Access Compliance Report Public Rights-of-Way (Curb Ramps)

Main Street: HEWES_AVE Cross Street: 17TH_ST Location: NE

ADA ID: RPRK211008123026 Ramp Type: Type 1 - Perpendicular Diagonal Initial Pass/Fail: Fail Overall Compliance: No Severity Score: 30

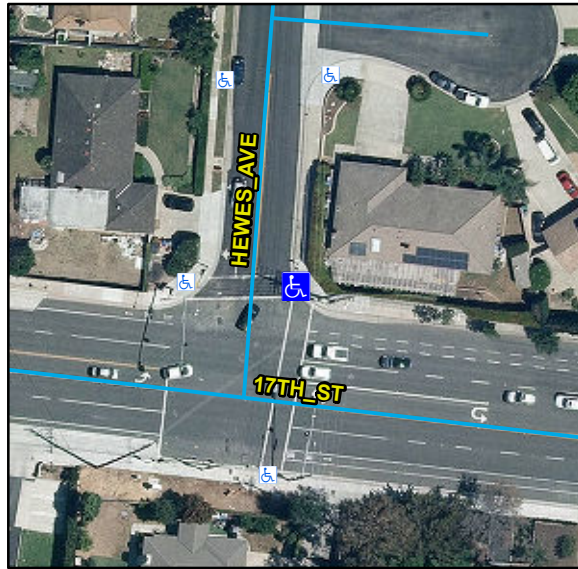
Compliance	Description	Data	Compliance	Description	Data
N/A	Ramp Length (in)	107	N/A	Flare Type LT	
Yes	Ramp Width (in)	48			N/A
Yes	Ramp Run Slope (%)	1.2	N/A	Flare Slope LT (%)	N/A
No	Ramp Cross Slope (%)	11	N/A	Flare Traversable LT	N/A
N/A	Landing Present	N/A	N/A	Flare Type RT	
N/A	Landing Length (in)	N/A			N/A
N/A	Landing Width (in)	N/A	N/A	Flare Slope RT (%)	N/A
N/A	Landing Run Slope (%)	N/A	N/A	Flare Traversable RT	N/A
N/A	Landing Cross Slope (%)	N/A	N/A	DWS Provided	N/A
N/A	Landing Movement Obstructed?	N/A	N/A	DWS Contrast	N/A
	Landing Movement Type	N/A	N/A	DWS Length (in)	N/A
N/A	Landing Shared	N/A	N/A	DWS Full Width	N/A
N/A	Clear Space	Yes	N/A	DWS Offset Left (in)	N/A
N/A	Clear Space To Crosswalk (in)	48	N/A	DWS Offset Right (in)	N/A
N/A	Marked Crosswalk 1	Yes	N/A	Marked Crosswalk 2	Yes
	Crossing 1 Direction	E		Crossing 2 Direction	S
	Marked Crosswalk 1 Width (in)	112		Marked Crosswalk 2 Width (in)	120

N/A	Ramp Inside Crosswalk 1	Yes	Yes	Ramp Inside Crosswalk 2	Yes
	Crossing 1 Slope (%)	7		Crossing 2 Slope (%)	0.6
	Crossing 1 Cross Slope (%)	4.2		Crossing 2 Cross Slope (%)	3.5
N/A	Gutter Ponding	N/A	No	Curb Slope	8.2
Yes	Gutter Lip Height (in)	0		Road Run Slope (%)	4.1
N/A	Gutter Run Slope (%)	N/A		Road Cross Slope (%)	8.6
N/A	Gutter Cross Slope (%)	N/A			
Yes	Overall Surface Condition: Acceptable		Yes	Perp Joint Present	Yes
	Cross Gutter Present?	No		Spandrel Present?	No
	Replace Cross Gutter?	N/A		Replace Spandrel?	N/A

Remove & Replace Curb Ramp With Two New Directional Ramps or Equivalent.
